# Quality of the scientific studies submitted by the Proponent for the EES

Presentation to the IAC as part of Mine Free Glenaladale's submission

Monday 7<sup>th</sup> June, 2021

## On-site weather station

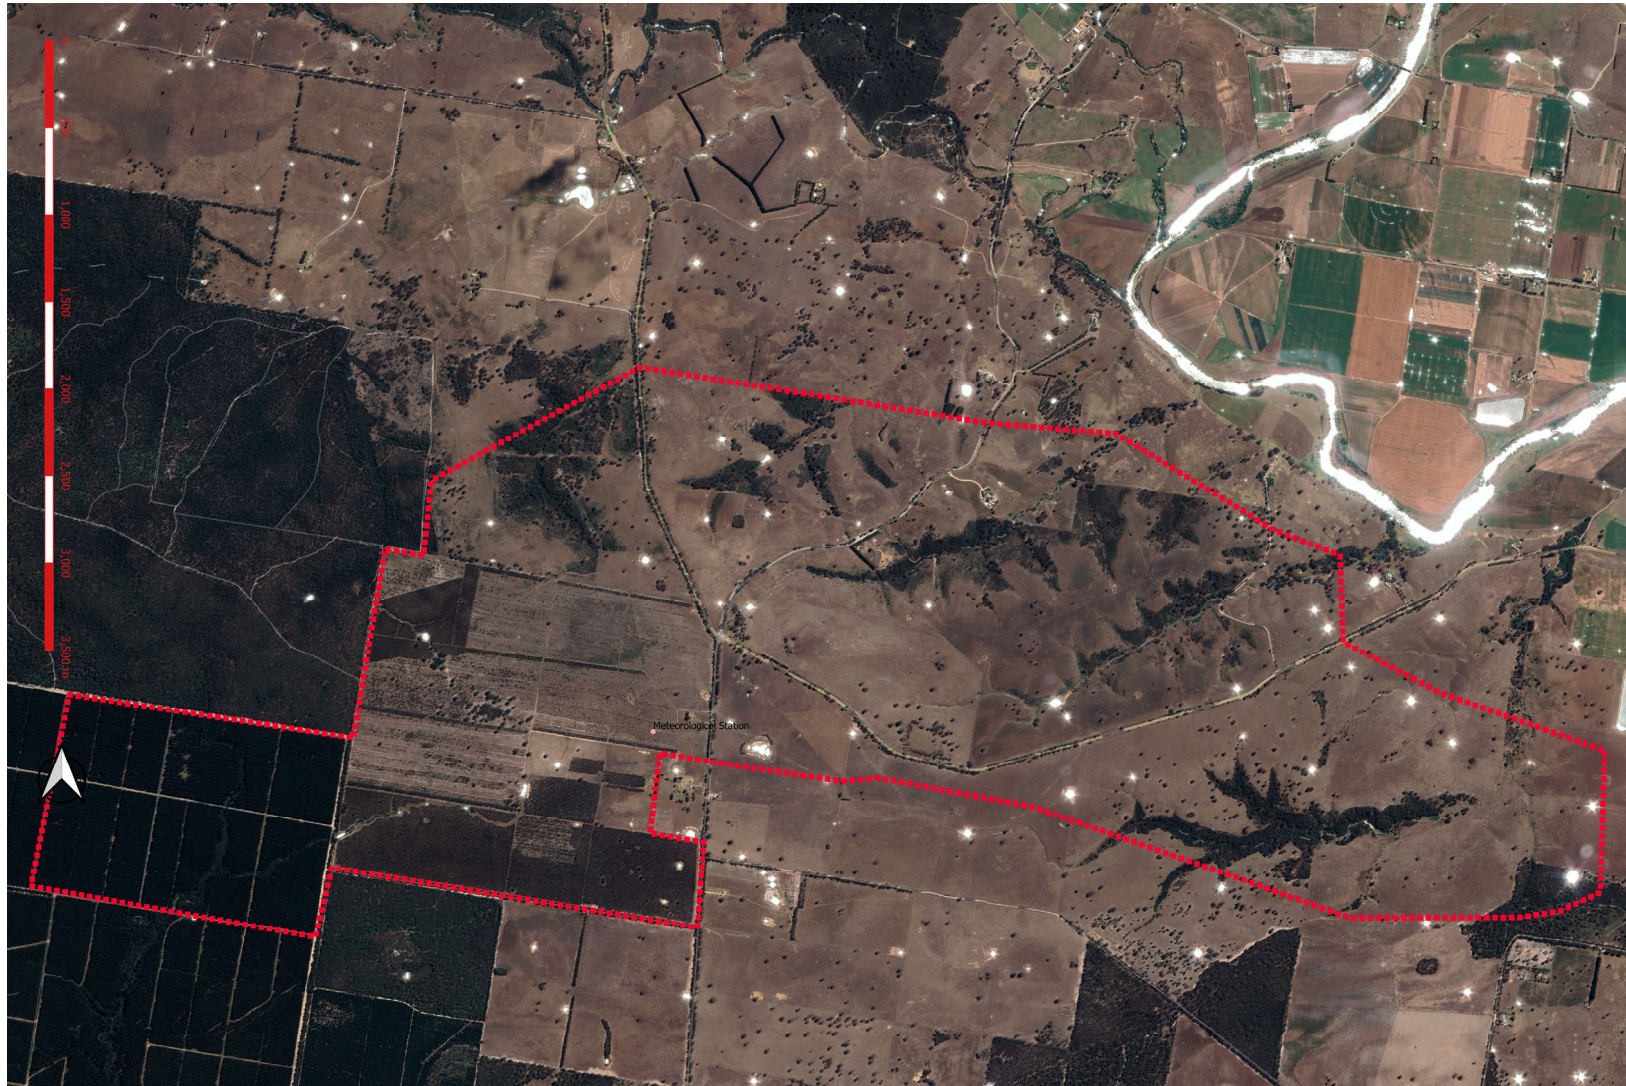
Incomplete data for wind speed and wind direction - only 77.3% due to several equipment faults

Location coordinates not provided

Location not representative of the proposed mine site

Located in a hollow

Downwind of wind break and large forested area

Run-off data

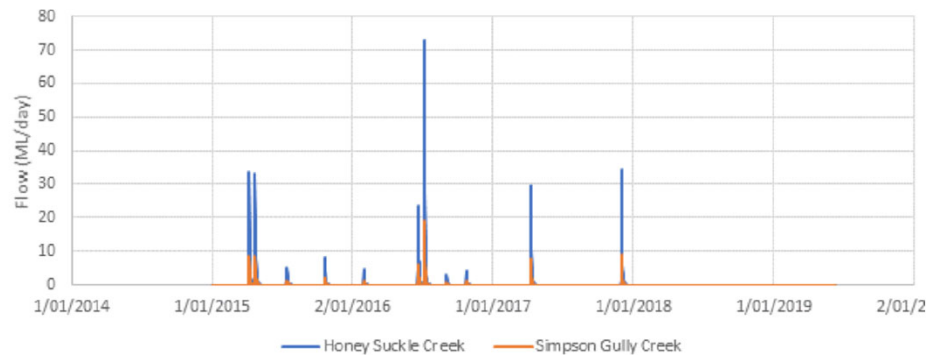
Very limited data and includes “assumed” data.

Fails to take into account the very severe drought with very limited vegetation.

## On-site particulate monitoring station

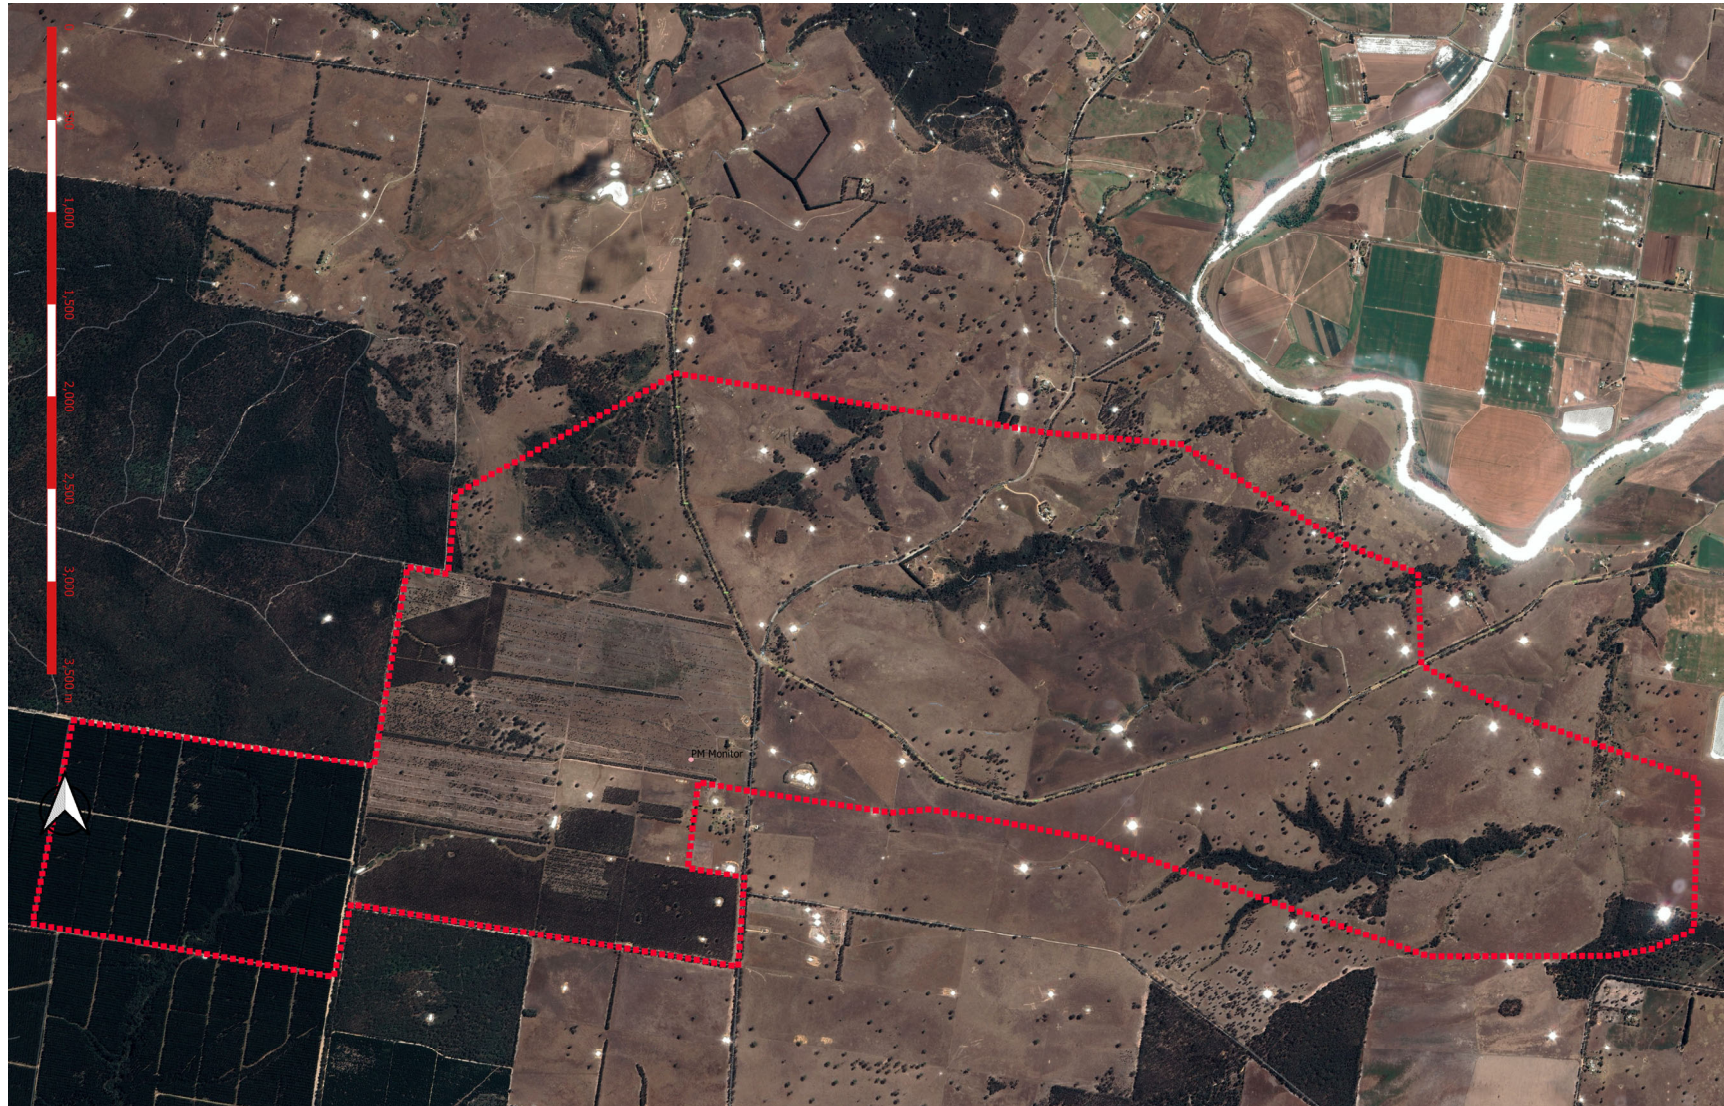
Location not representative of the proposed mine site

Located in a hollow

Downwind of windbreak and large forested area

Ecotech is not NATA accredited for a number of the methods used in the background monitoring. This particularly applies to small particles - PM2.5.
